PCN# : P685AAB  
Issue Date : Aug. 31, 2016

### Information Only Notification

TO263 Carrier tape

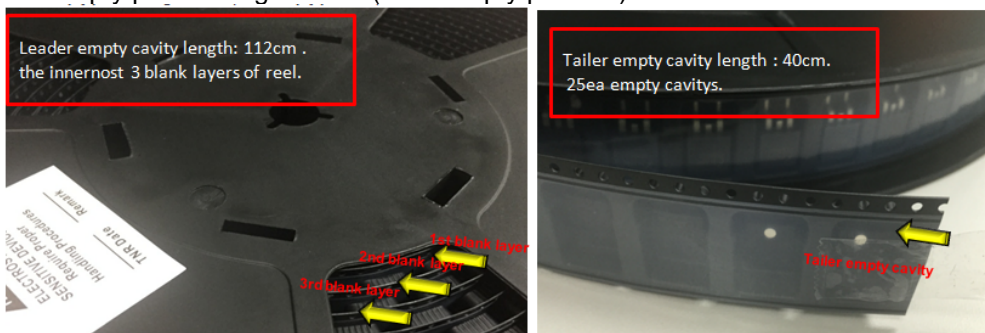
Description of Change (From) :

Lead empty length: 72cm(45ea empty pockets, the innermost 2 blank layers of reel).

Tail empty pocket length: 80cm(50ea empty pockets).

Description of Change (To) :

Lead empty length: 112cm(70ea empty pockets, the innermost 3 blank layers of reel).

Tail empty pocket length: 40cm(25ea empty pockets).

The change is to mitigate lead deformation during product transportation.
